Request - Special Use Permit for Used Auto Sales  
Location - 631 S. Reynolds Road  
Applicant/Owner - Wasfi Al-Badour  
4708 Ryan Road  
Toledo, OH 43614  
Engineer - David Golis, PE, CBO  
5505 Pickle Road  
Oregon, OH 43616

The staff recommends that the Toledo City Plan Commission recommend approval of SUP25-0041, a Special Use Permit for Used Auto Sales at 631 S. Reynolds Road, to Toledo City Council, for the following **two (2) reasons**:

SPECIAL USE PERMIT  
TOLEDO CITY PLAN COMMISSION  
REF: SUP25-0041  
DATE: February 12, 2026  
TIME: 2:00 P.M.

# SITE PLAN

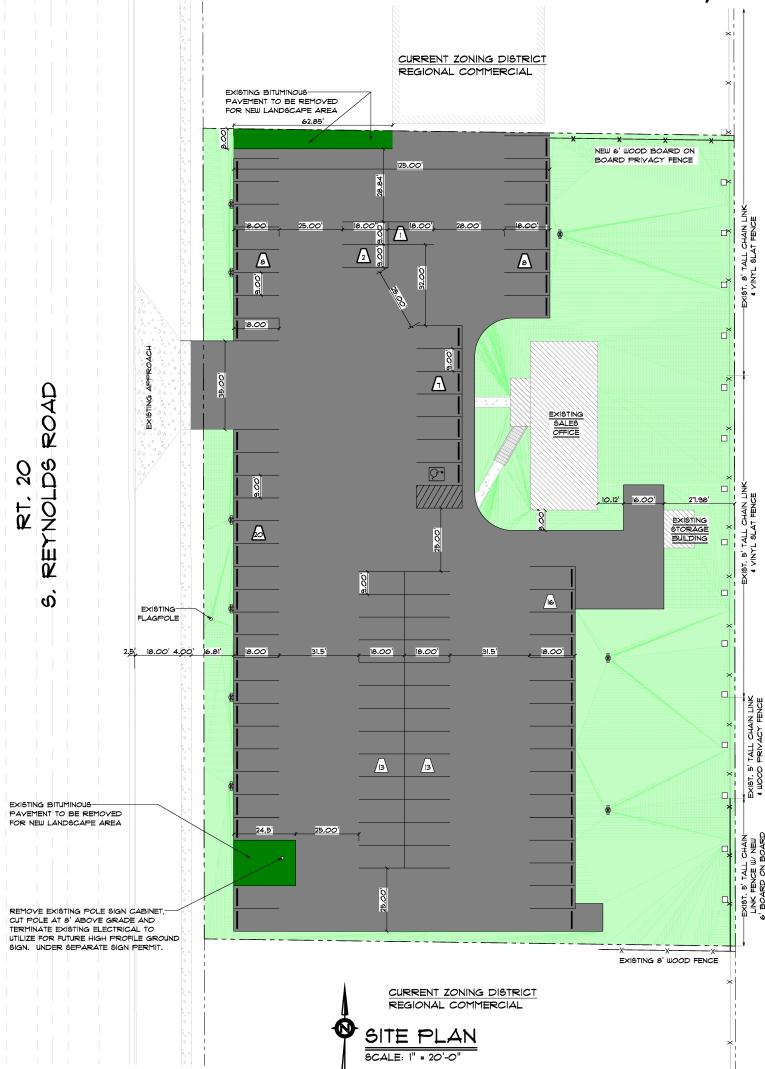
TMC§1107.0400 permits a maximum of one (1) off-street parking space per 5,000 square feet of open sales area. As discussed, an outdoor display area has not been defined on the site plan. Once defined, the applicant must ensure this maximum parking ratio is not exceeded. This has been added as a condition of approval.

Per TMC§1107.1700 *Accessible Parking for Physically Disabled Persons*, a minimum of three (3) auto-accessible and one (1) van-accessible parking spaces are required. Such spaces must be located in close proximity to building entrances and must be identified with signs and pavement markings. The applicant currently proposes one (1) van-accessible space and no auto-accessible spaces. The addition of these spaces has been added as a condition of approval.

1. Three (3) auto and one (1) van accessible parking spot with a 5' loading aisle for auto and an 8' loading aisle for van is required per TMC 1107.1701 & 1107.1702.

12. Off-street parking spaces for customers/employees shall be clearly delineated from spots within the outdoor display area. **Not acceptable as depicted. A revised site plan shall be submitted to the Plan Director depicting a clear delineation between outdoor display area parking spots and customer/employee parking spots.**

# LANDSCAPE PLAN

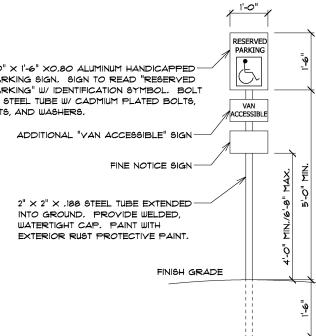
Per TMC§1108.0202 *Frontage Greenbelt*, a landscape greenbelt consisting of eleven (11) trees and a solid evergreen hedge is required along Reynolds Road. The applicant has proposed ten (10) trees and a solid evergreen hedge. The addition of one (1) more tree has been added as a condition of approval.

Per TMC§1108.0204 *Parking Lot Landscaping*, perimeter landscaping is required along any parking lot area visible from an immediately adjacent property. Perimeter landscaping is already provided to the south by the adjacent property owner. However, no such landscaping has been installed along the northern property line. The applicant has proposed landscaping on the northern property line where visible. Two (2) trees and a continuous shrub with a minimum height of eighteen inches (18") is required within this northern landscaping. This has been added as a condition of approval.

13. The number of off-street parking spaces shall not exceed one (1) space for every 5,000 square feet of open sales area per TMC§1107.0400.
14. A fifteen-foot (15') buffer of landscaped frontage greenbelt meeting the requirements of TMC§1108.0202 is required along S. Reynolds Road. **Not acceptable as depicted. The applicant shall submit a revised landscape plan to the Plan Director depicting a minimum of eleven (11) trees along S. Reynolds Road.**

15. Perimeter parking lot landscaping meeting the requirements of TMC§1108.0204 is required along the northern property line where visible from the adjacent property. **Not acceptable as depicted. The applicant shall submit a revised landscape plan to the Plan Director depicting a minimum of two (2) trees and a continuous shrub with a minimum height of eighteen inches (18").**
